Work Order ID 144047

Item Name: Quick Release Heli-Utility-Basket™ Long, Light Lid, Spacepod™/Squirrel Cheek Comp

DART SERVICE INSTRUCTION

TO AMEND INSTALLATION INSTRUCTIONS D350-607-3 Rev.D,
INSTALLATION INSTRUCTIONS D350-607-4 Rev. C AND
INSTRUCTIONS FOR CONTINUED AIRWORTHINESS ICA-D350-607 REV. 6

FIGURE 1: INSTALLATION OF D4775-041 FWD STRUT

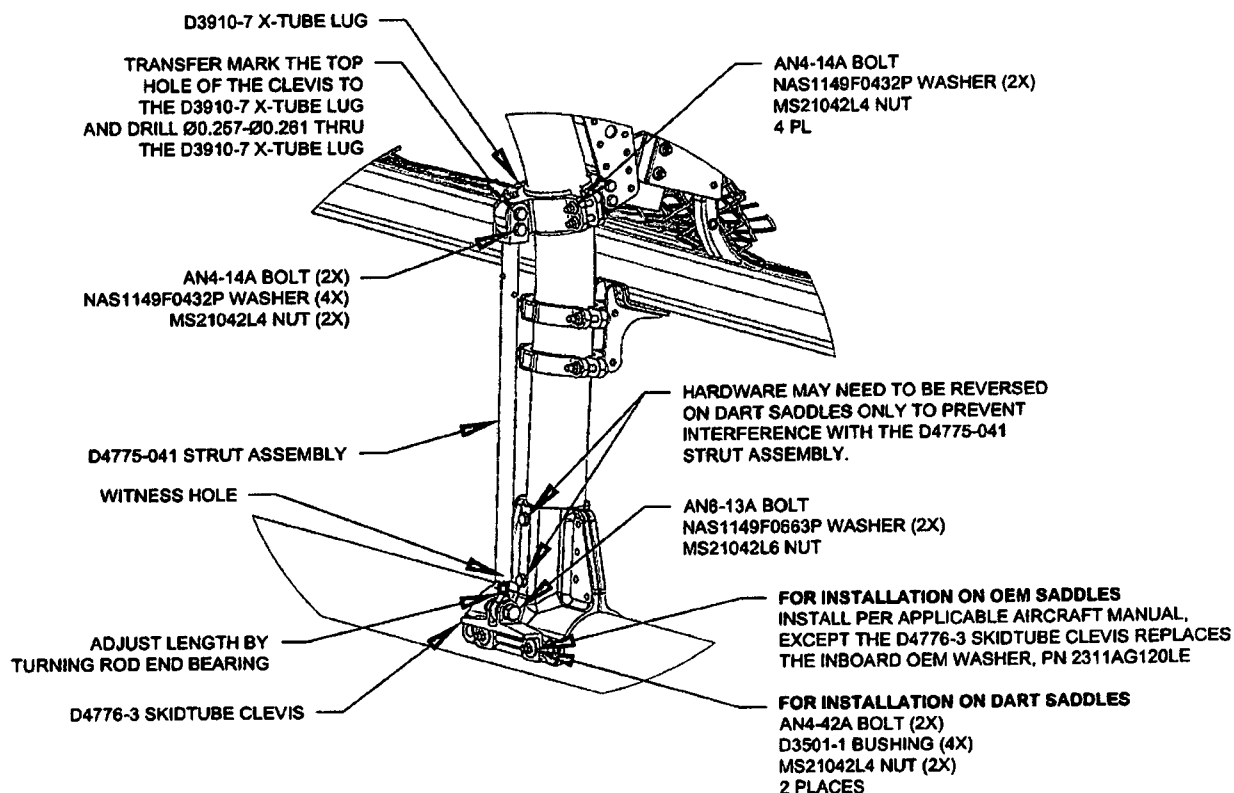
- 3.1 Substitute the Forward Lower D3910-5 X-Tube Lug with the D3910-7 X-Tube Lug as shown in Figure 1.
- 3.2 Install the forward D4775-041 Strut Assembly. Transfer mark from the upper hole on the clevis of the D4775-041 Strut Assembly to the D3910-7 X-tube Lug and drill thru the lug $\varnothing 0.257$ - $\varnothing 0.261$ as shown in Figure 1. Touch up chemical conversion coating per MIL-DTL-5541. Check the witness holes located at the bottom end of the D4775-041 Strut Assemblies to ensure that the thread from the rod end extends past the witness hole.
Torque MS21042L4/-4 nuts to 50-70 in-lbs (5.7-7.9 N-m). Torque MS21042L6/-6 nuts to 160-190 in-lbs (18.1-21.5 N-m).
- 3.3 Complete the installation in accordance with Installation Instructions D350-607-3 Rev. D or D350-607-4 Rev. C.

Install the D350-607-501 Conversion Kit, D350-607-511 Quick Release Mounting Kit or D350-607-431 Strut retrofit kit per Installation Instructions D350-607-3 Rev. D or D350-607-4 Rev. C. While installing the Forward Strut perform the following:
